ADDENDUM NO. 2
TO
BIDDING AND CONTRACT
REQUIREMENTS AND SPECIFICATIONS
FOR THE
TOWN OF EXETER, NH CONTRACT 4 WWTF LAGOON NO. 1 SLUDGE REMOVAL
WP PROJECT NO. 12883C-C4

TOWN OF EXETER, NH CONTRACT 4 WWTF LAGOON NO. 1 SLUDGE REMOVAL

ADDENDUM NO. 2

WP PROJECT NO. 12883C-C4

WRIGHT-PIERCE Engineering a Better Environment Offices Throughout New England www.wright-pierce.com 888.621.8156	
EXETER, NEW HAMPSHIRE CONTRACT NO. 4 WASTEWATER TREATMENT FACILITY LAGOON 1 SLUDGE REMOVAL SITE LAYOUT PLAN	
DRAWING C4-1

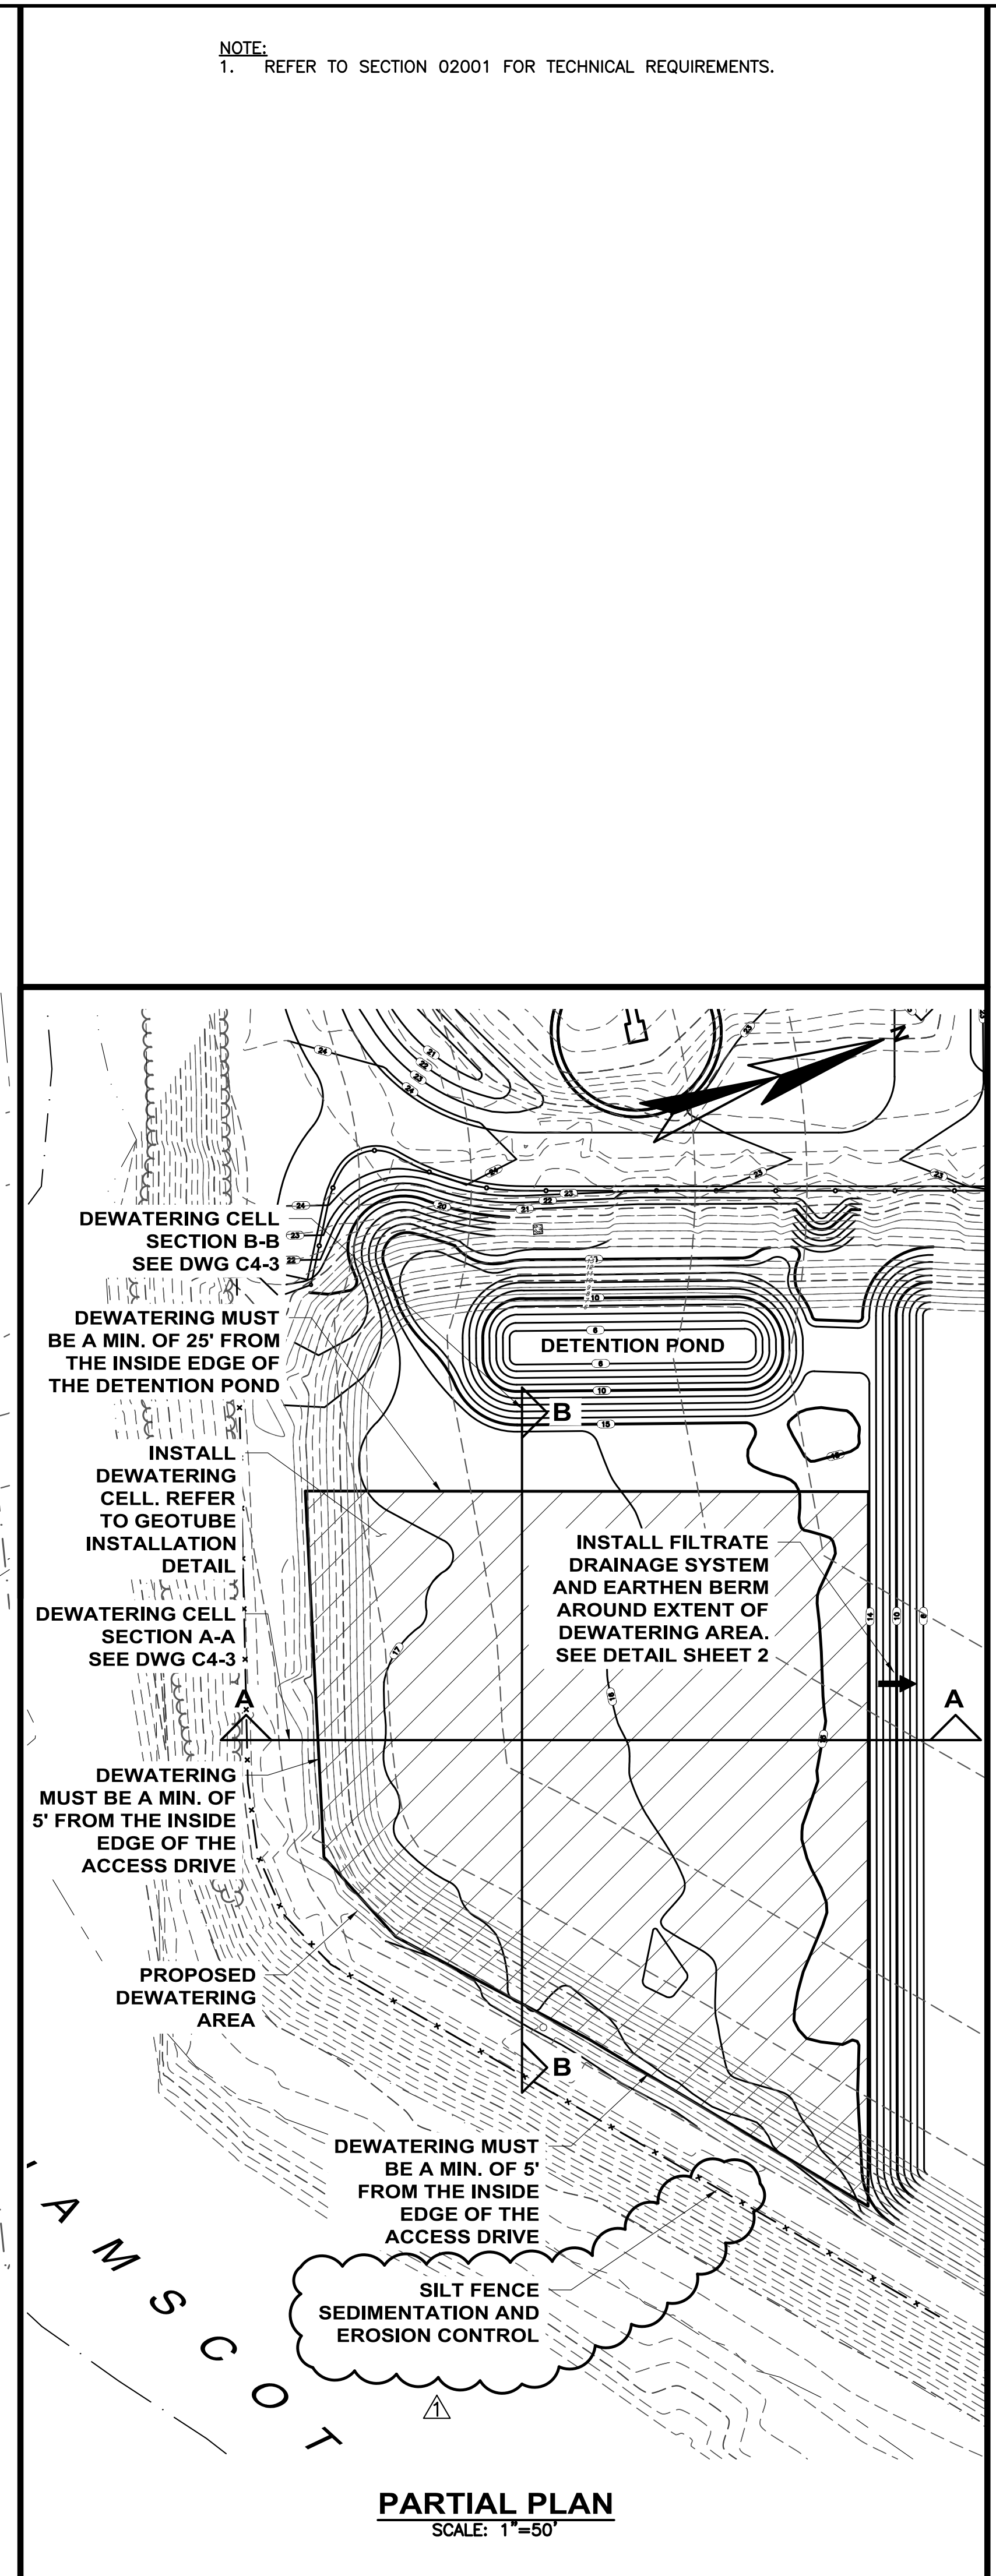
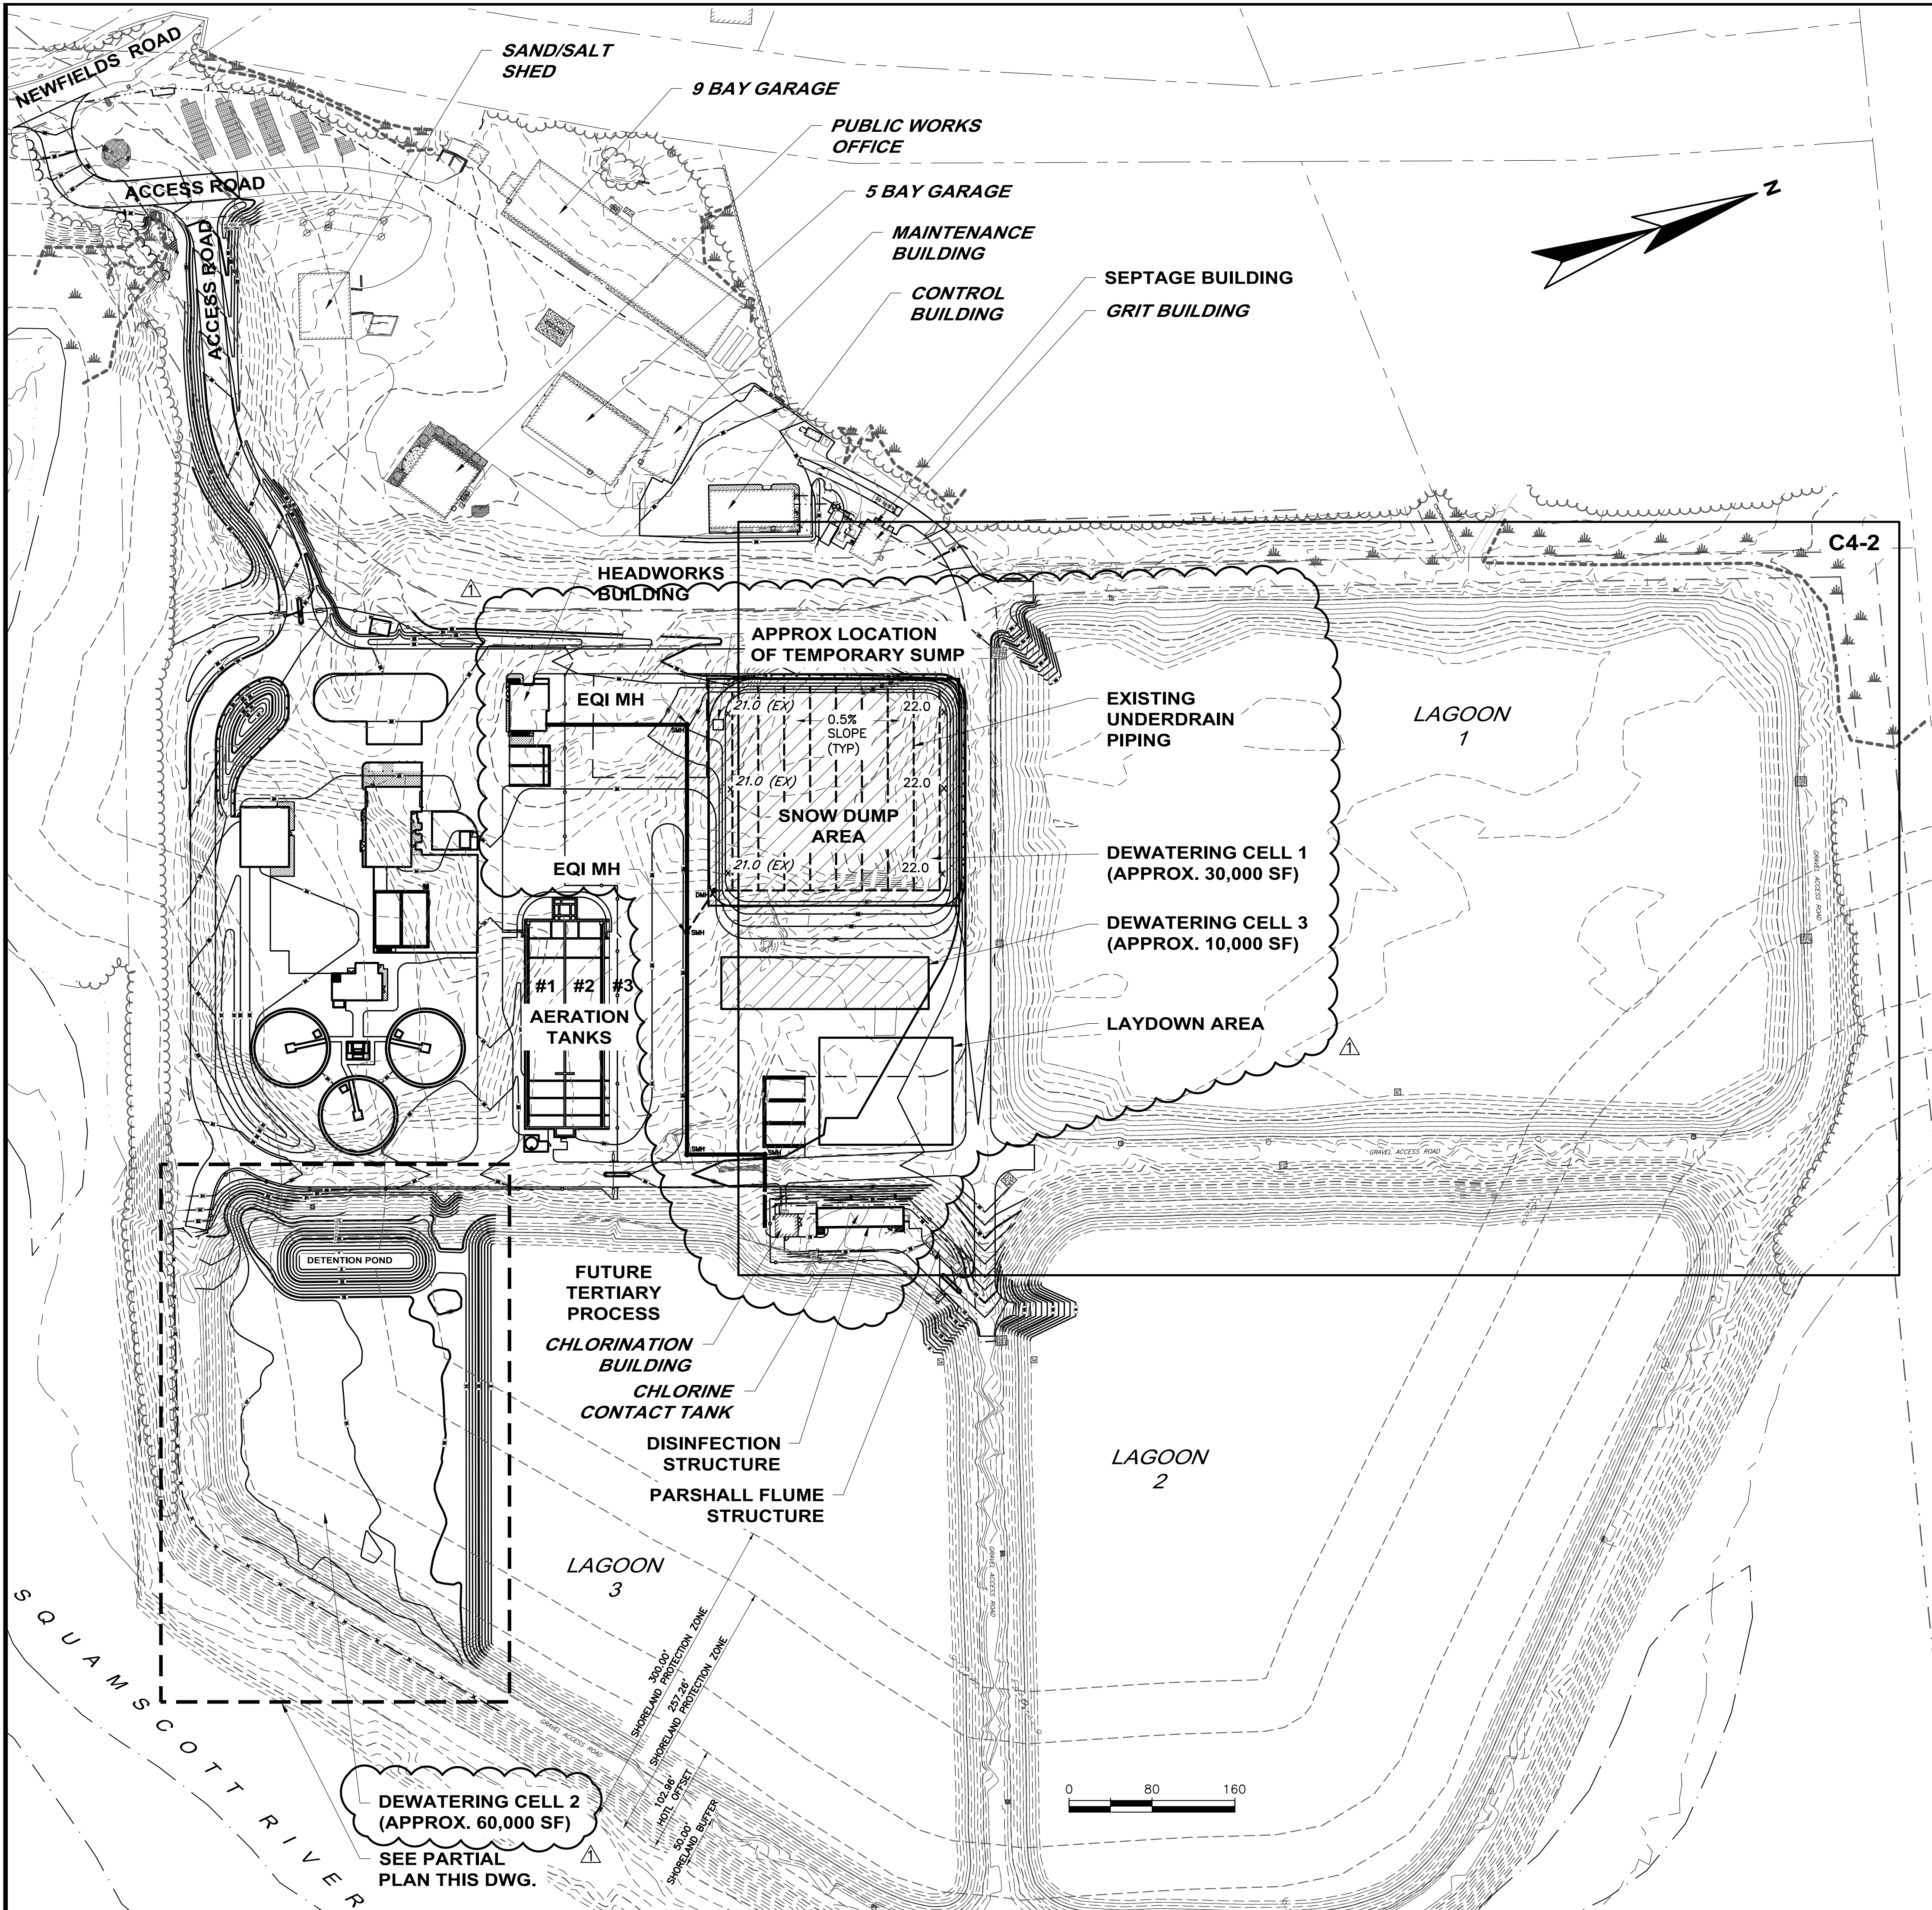
Drawing C4-1: **REPLACE** with the attached revised version.

- 2. Is there any silt fence required for any of this project?**
Yes, some erosion control fencing will be required as shown on the revised drawings.
- 3. Will the plant operators take over the management of any filtrate water exiting the tubes when the project is complete and the contractor leaves the site? If not, then who?**
The Town will manage filtrate following demobilization except for warranty issues (e.g., tube failure).

A laydown area has been indicated on the revised drawings. There are several other small areas on-site that can be made available for laydown.
